## FINAL ORDER

The Special Standards Request Form you submitted for owner: Hood River Cherry Co., for Start Card number: 1060828, is hereby approved for the following: You may construct this water supply well, placing bentonite between the 16- and 12-inch casing, as described on your Special Standards Request Form dated July 17, 2023. All other well construction standards must be adhered to. A copy of your Special Standards Request Form is enclosed.

# Special Standards Request Form

## REQUEST FOR WRITTEN APPROVAL TO USE CONSTRUCTION METHODS NOT INCLUDED IN OREGON ADMINISTRATIVE RULES 690-200 THROUGH 690-240

See attached Diagram

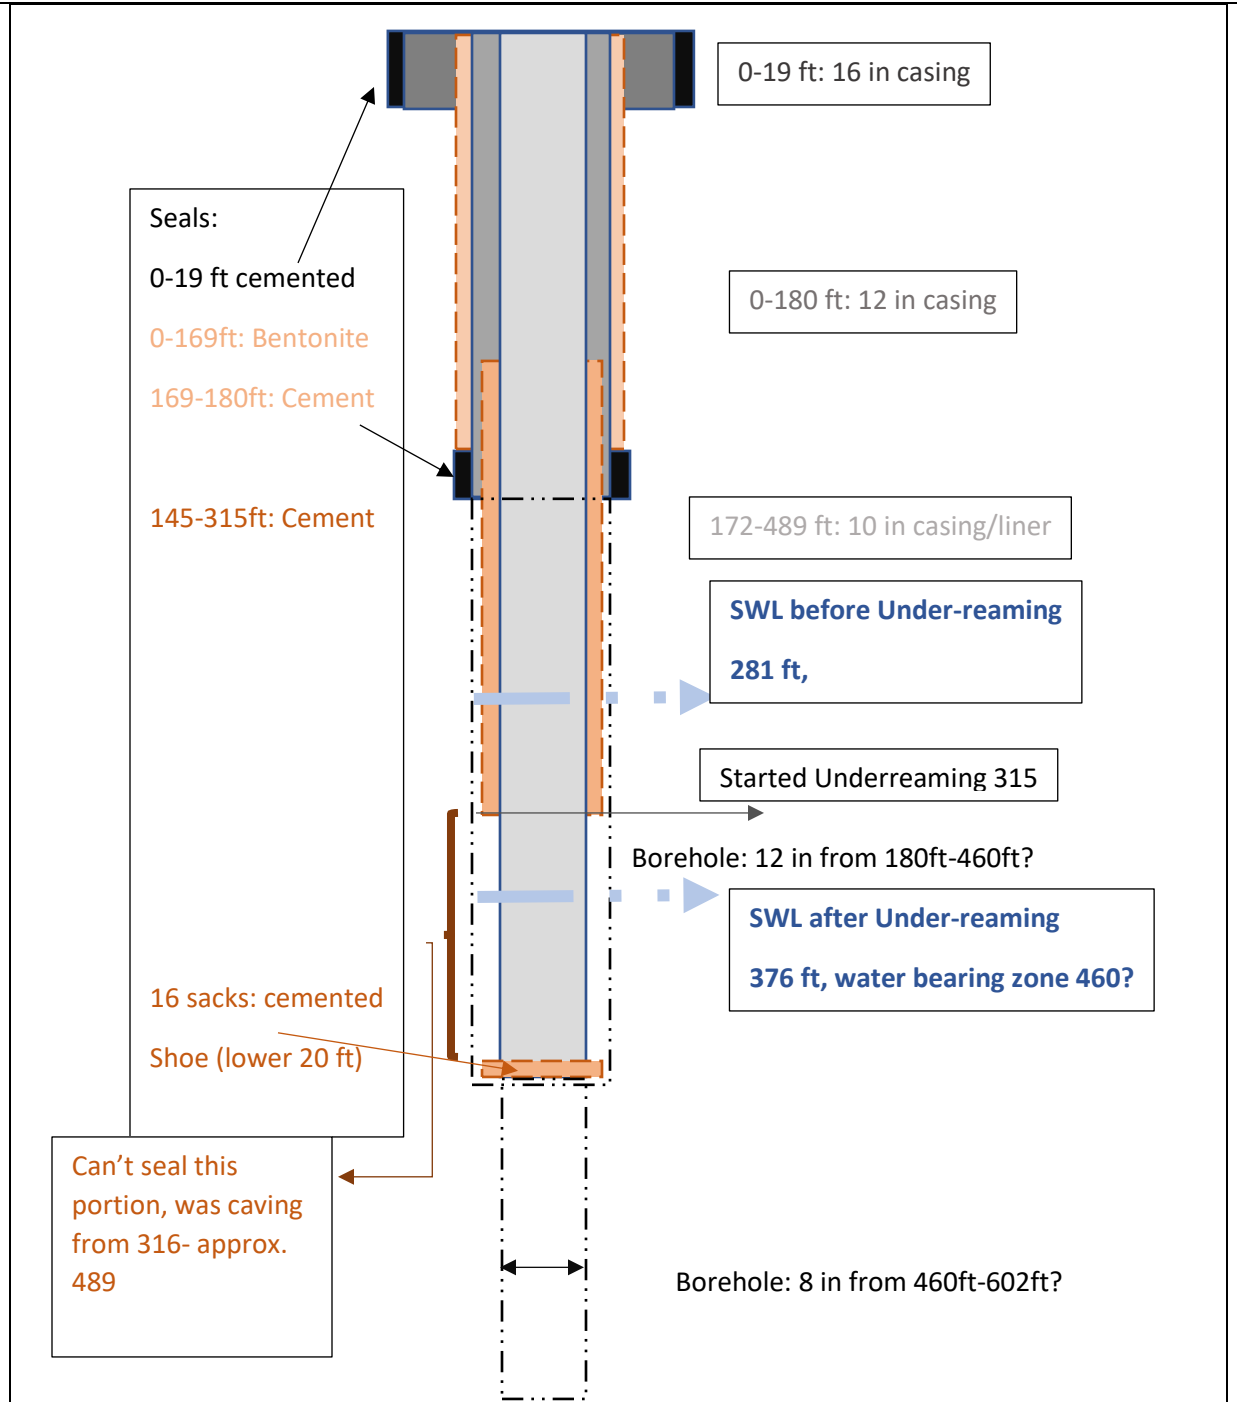
- (10) The Unusual Site Conditions Which Necessitate this Request: Unable to  
Terminate casing in unfractured rock, Caving  
badly 315' - 460
- (11) The Proposed Construction Methods the Bonded Well Constructor Believes will be Adequate for this Well (attach additional pages if needed): Bottom of casing  
sealed with 16 sacks of cement, Split Seal and  
bentonite seal between 16" and 12"

Pictures Based on the details from being onsite and rough well log

Unconsolidated units for entire depth down to 602 ft

Approval of this Special Standards Request was granted on July 14, 2023 due to you reporting the caving conditions from 315 to 460 feet and being unable to keep the borehole open to place seal.
